Addendum #02

Fox Pointe Townhomes
800-927 23rd Ave NW
Austin, MN 55912

8/31/17

615-19

1 SILL DETAIL @ ENTRY DOOR
6" = 1'-0"

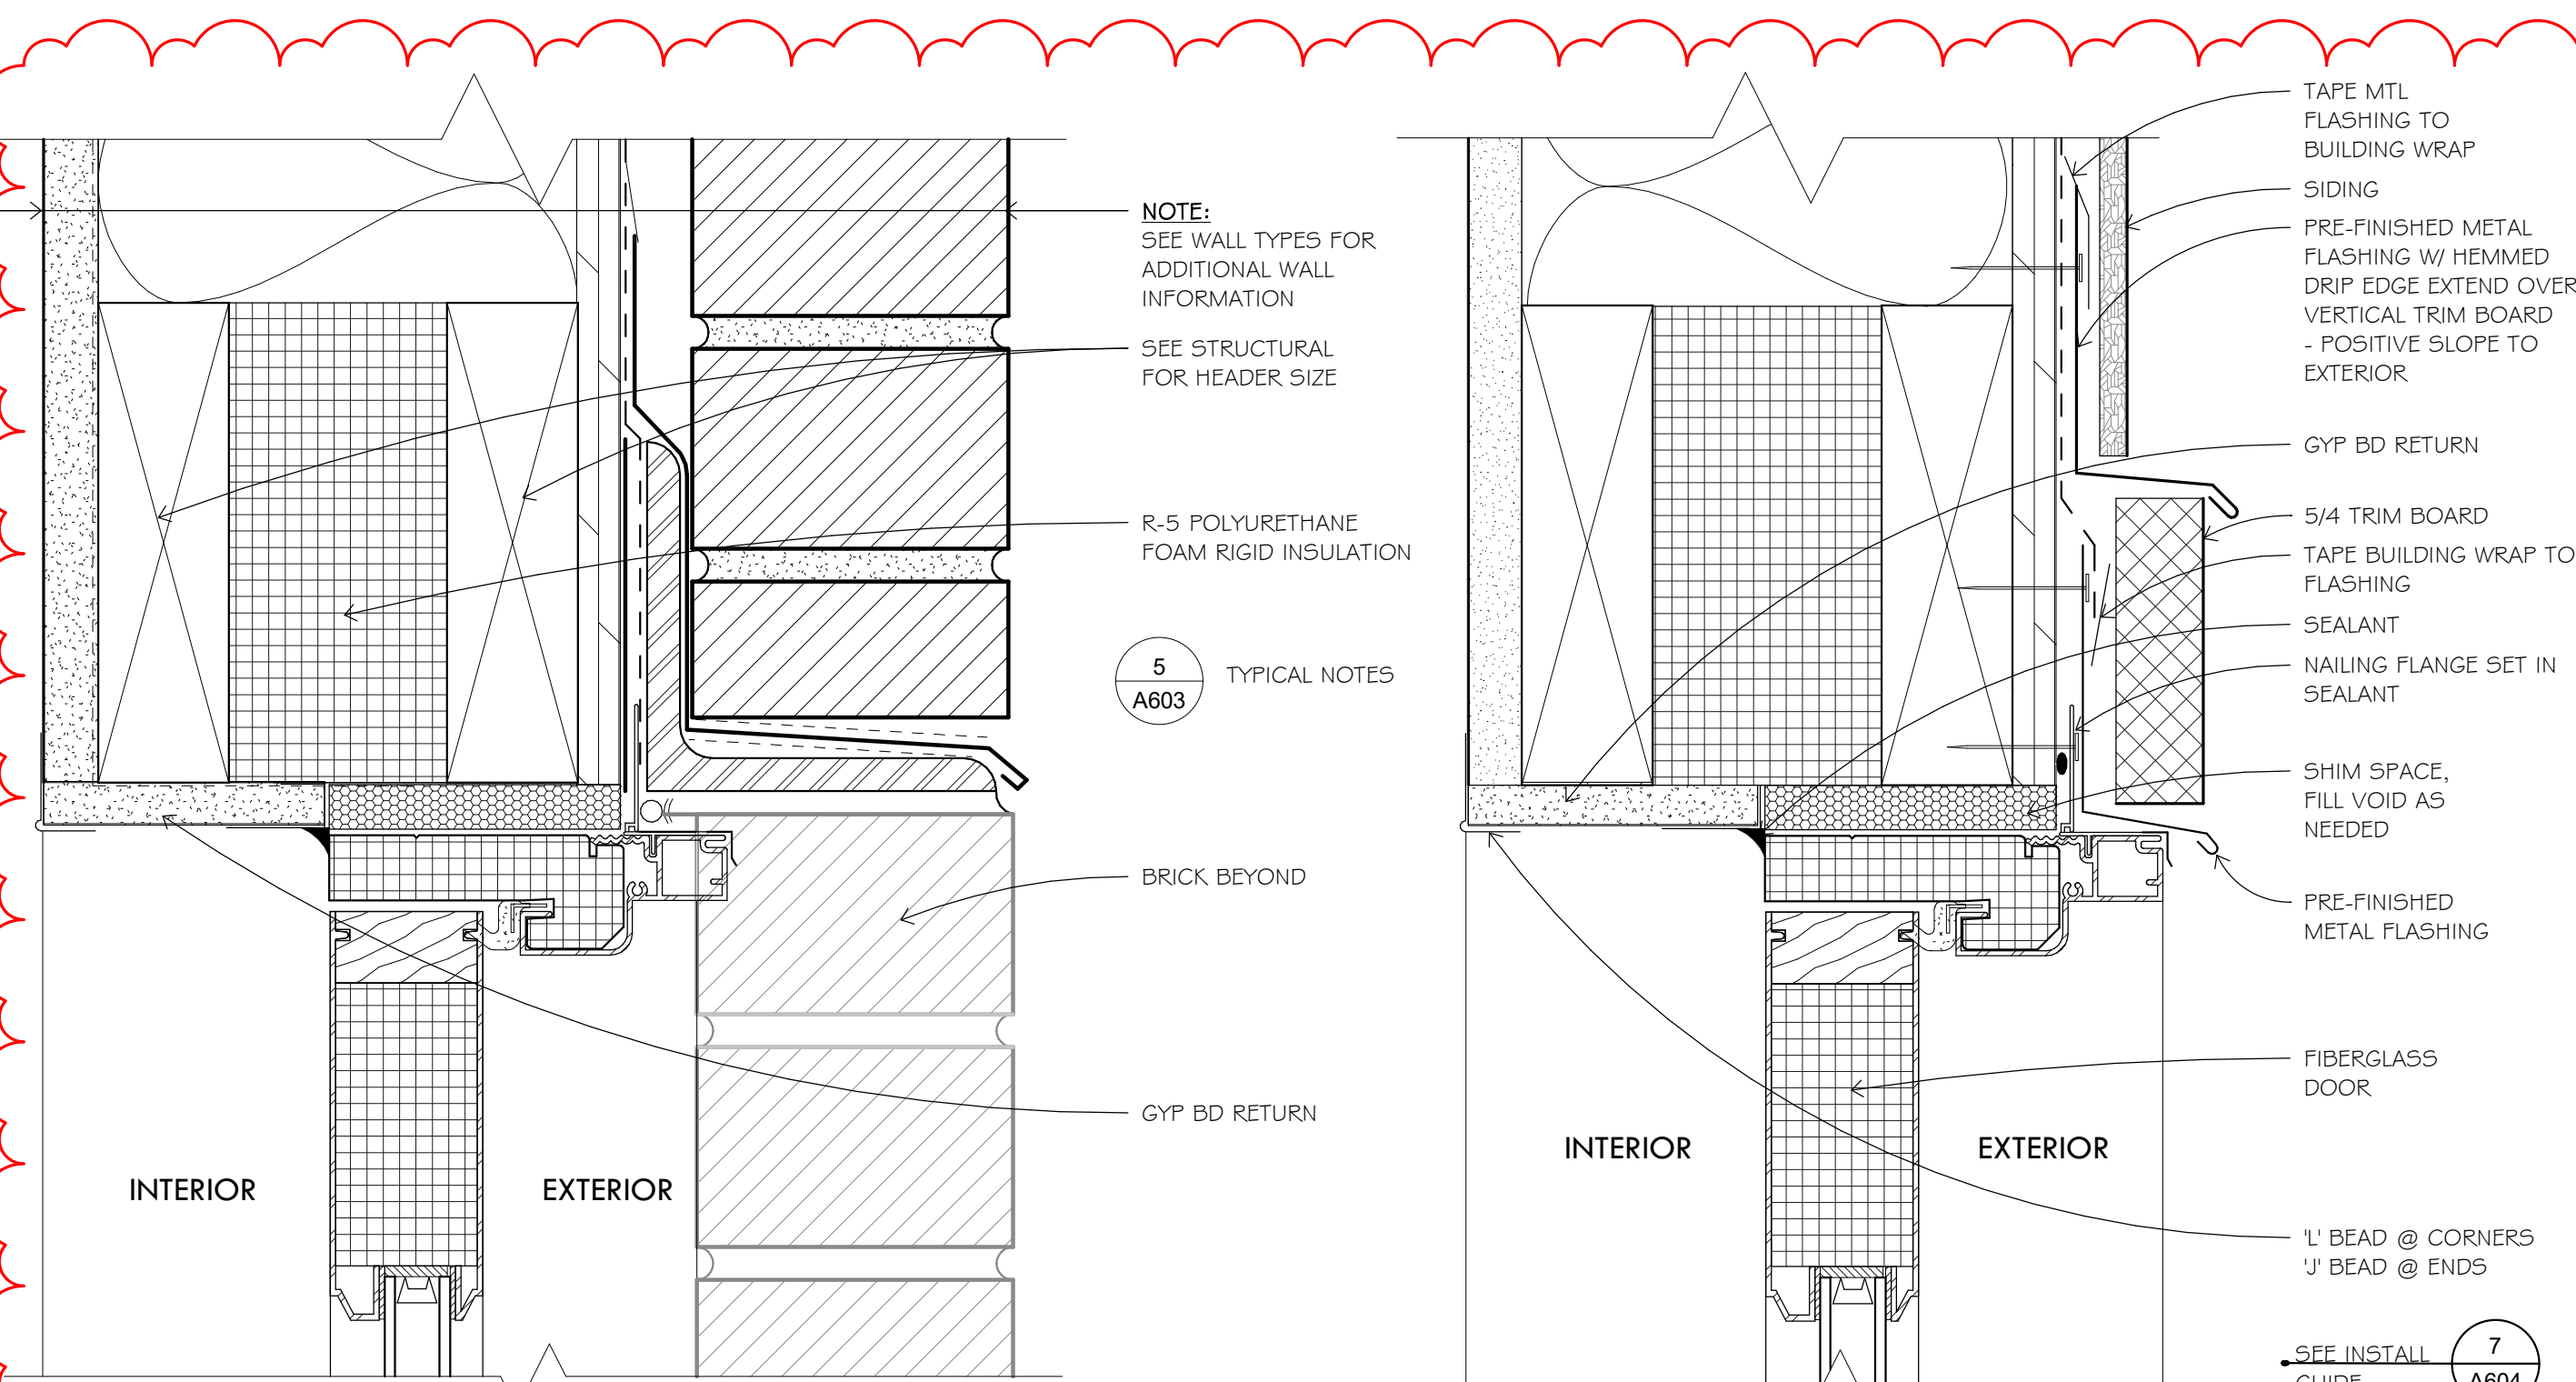
- a. Detail 1/A604- SILL DETAIL @ ENTRY DOOR – modified this addendum
 - b. Detail 2/A604- DOOR JAMB DETAIL @ SIDING – modified this addendum
 - c. Detail 4/A604 – DOOR HEAD DETAIL @ SIDING – modified this addendum

2 PATIO DOOR JAMB DETAIL (SLIDING DOOR)
6" = 1'-0"

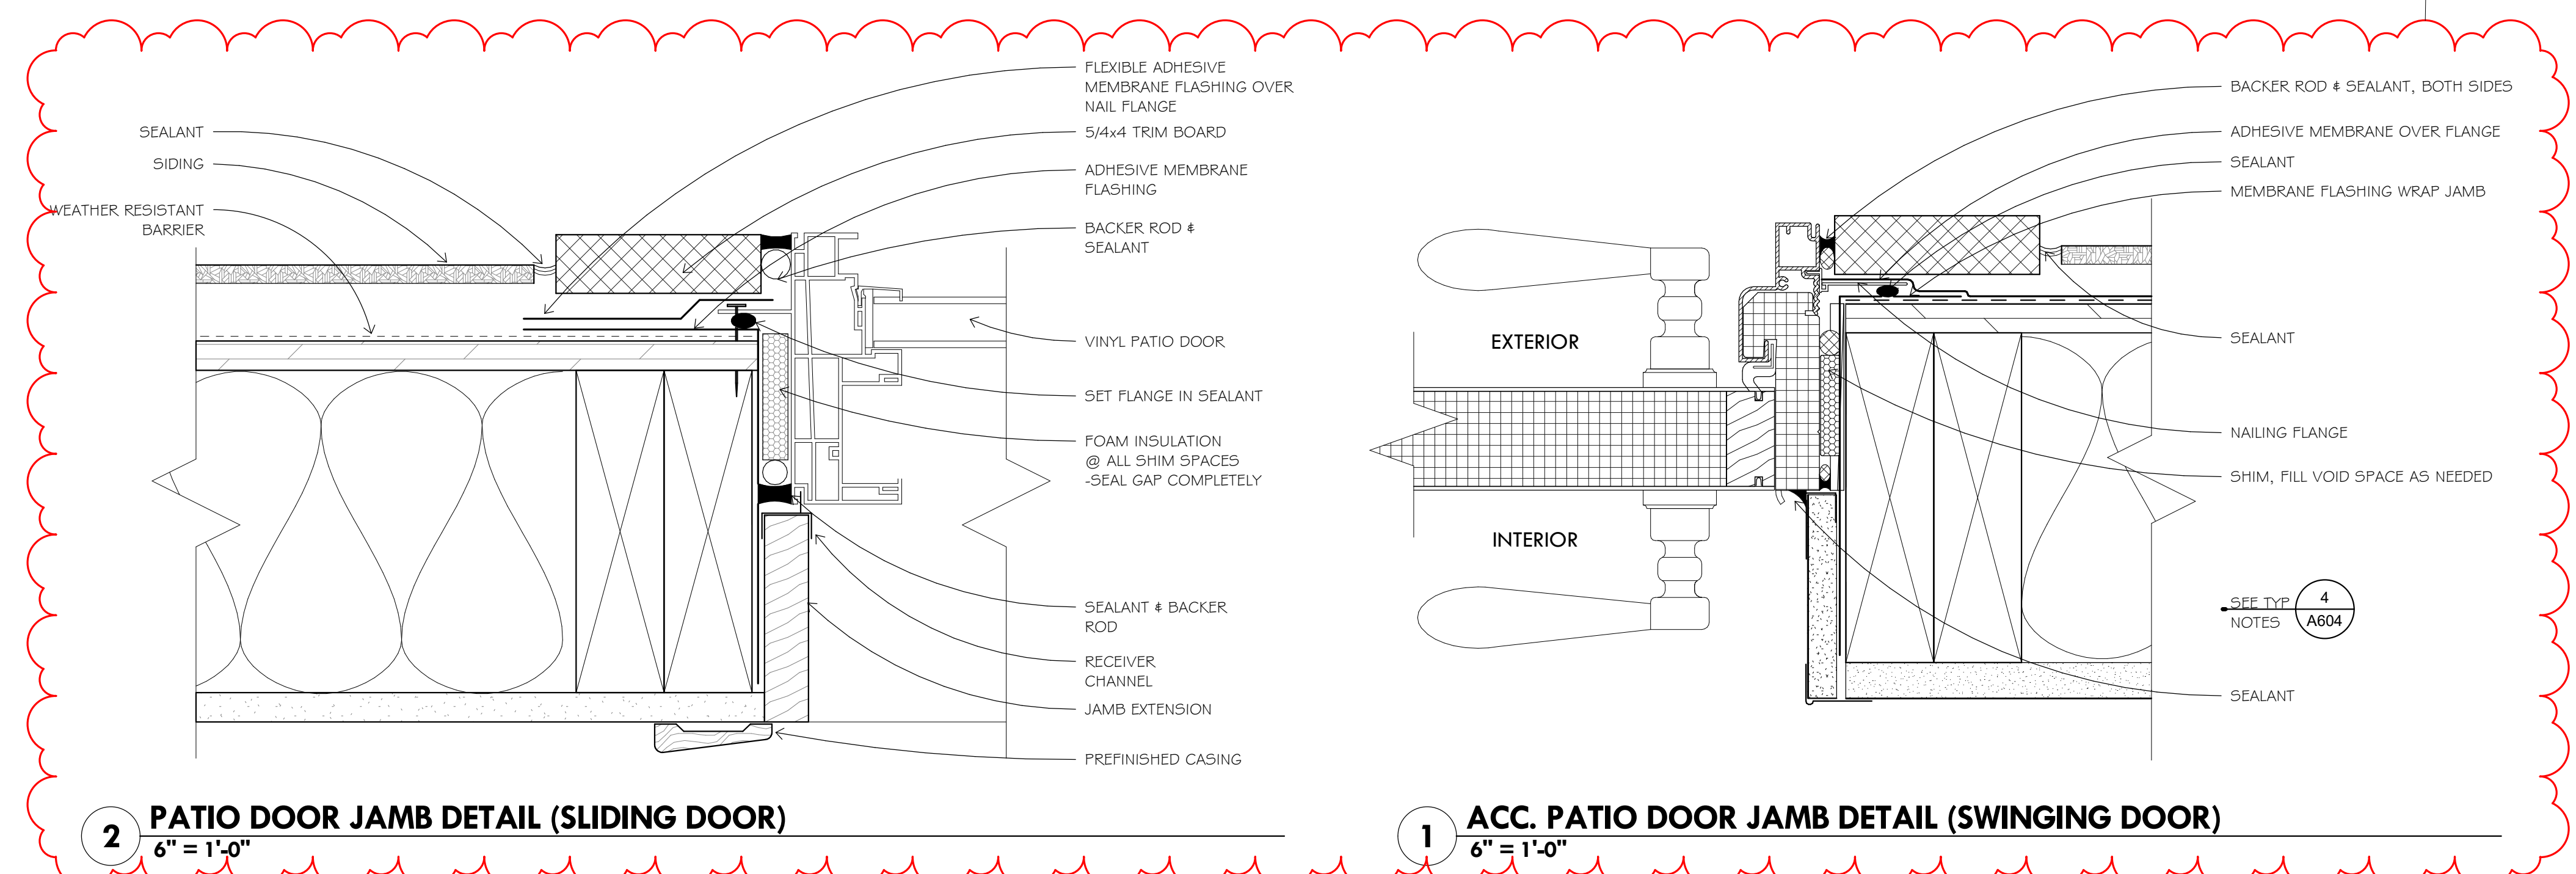
- b. Detail 2/A605- PATIO DOOR JAMB DETAIL (SLIDING DOOR) – modified this addendum
- 7. Refer to A702 – INTERIOR ELEVATIONS – ADA UNITS / OFFICE
 - a. Elevation 12/A702 – MAINTENANCE CASEWORK ELEV. – modified this addendum

1 ACC. PATIO DOOR JAMB DETAIL (SWINGING DOOR)
6" = 1'-0"

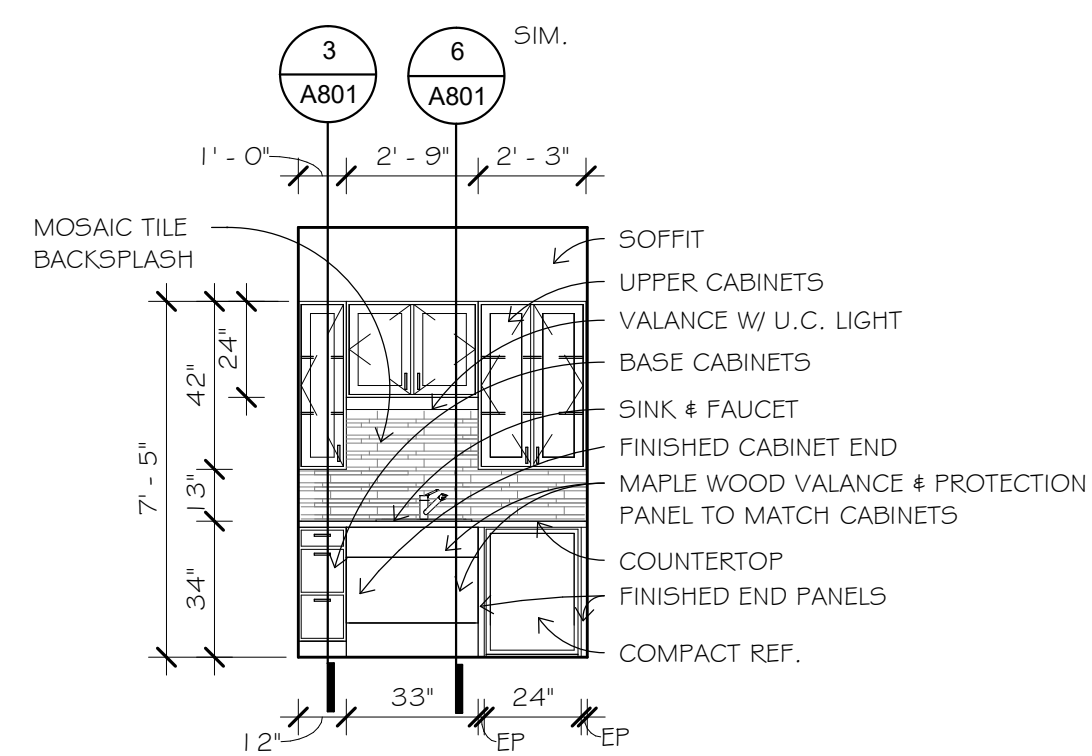
- d. Detail 5/A604 – DOOR HEAD DETAIL @ BRICK – modified this addendum
- 6. Refer to A605 – EXTERIOR DETAILS - OPENINGS
 - a. Detail 1/A605- ACC. PATIO DOOR JAMB DETAIL (SWINGING DOOR) – modified this addendum
